Subject: MHI's Responses to US-APWR DCD RAI No. 340-2004

Reference: 1) "Request for Additional Information No. 340-2004 Revision 0, SRP Section: 03.08.05 – Foundations, Application Section: 3.8.5," dated 4/21/2009.

Responses to Request for Additional Information No. 340-2004,
Revision 0

Figure 1 Connection Modeling of Elements of Different Type

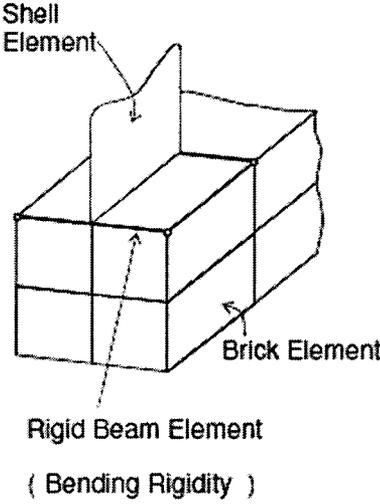
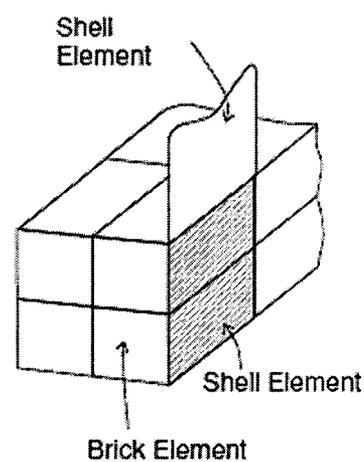
In DCD Figure 3.8.5-10, it is indicated in the figure caption that solid elements were used to model the basemat, and in DCD Table 3.8.1-4 it is indicated that shell elements were used to model the PCCV. Also, in DCD Subsection 3.8.3.4.1, it states that the SC modules were modeled by the shell elements. Since the shell element has six degrees of freedom and the solid element has only three translational degrees of freedom for every node, explain how shell elements are connected to the solid elements.

In the three-dimensional FE models shown in Figures 3.8.5-5 through 3.8.5-10, shell elements have six degrees of freedom and solid elements have three translational degrees of freedom for every node. In order to keep continuity of stress and deformation, additional elements should be used as shown in Figure 1.

Table 3.8.5-5 Typical Reinforcement in PS/B Basemat

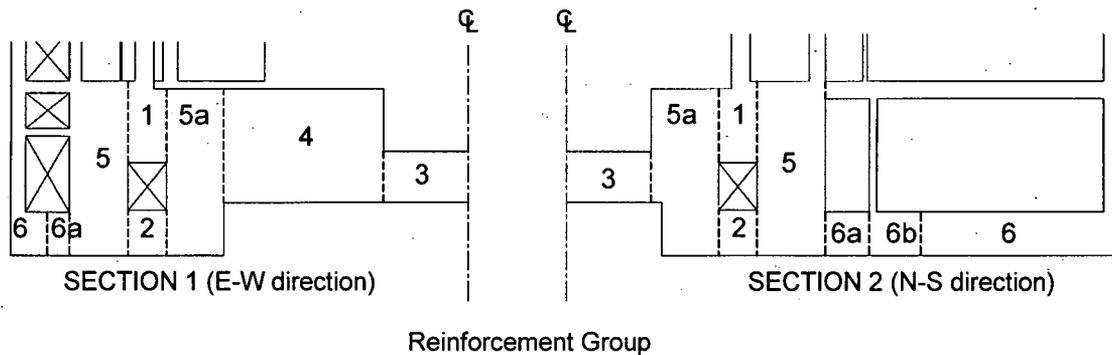
In DCD Tables 3.8.5-4 and 3.8.5-5 add an extra column that provides information that identifies the control load case for each section listed. Please indicate in which revision of the DCD the revised tables will appear.

The DCD will be revised to include an extra column in Tables 3.8.5-4 and 3.8.5-5 that provides information that identifies the control load case for each section. In addition, the numbering of locations in the first column will be changed to superscripts to align with the notes on Table 3.8.5-4 Sheet 2 of 2. These changes will appear in Revision 2 of the US-APWR DCD.

- Change the left column of Note 5 on Table 3.8.5-4, Sheet 2 of 2, to the following:
"5, 5a Outside Secondary Shield Wall"
- Add the following as Note 7 on Table 3.8.5-4, Sheet 2 of 2:
"7 For the controlling load cases of locations 1 through 5a, see DCD Table 3.8.1-2. For controlling load cases of locations 6 through 6b, see DCD Table 3.8.4-3."
- Replace Table 3.8.5-5 with the following:
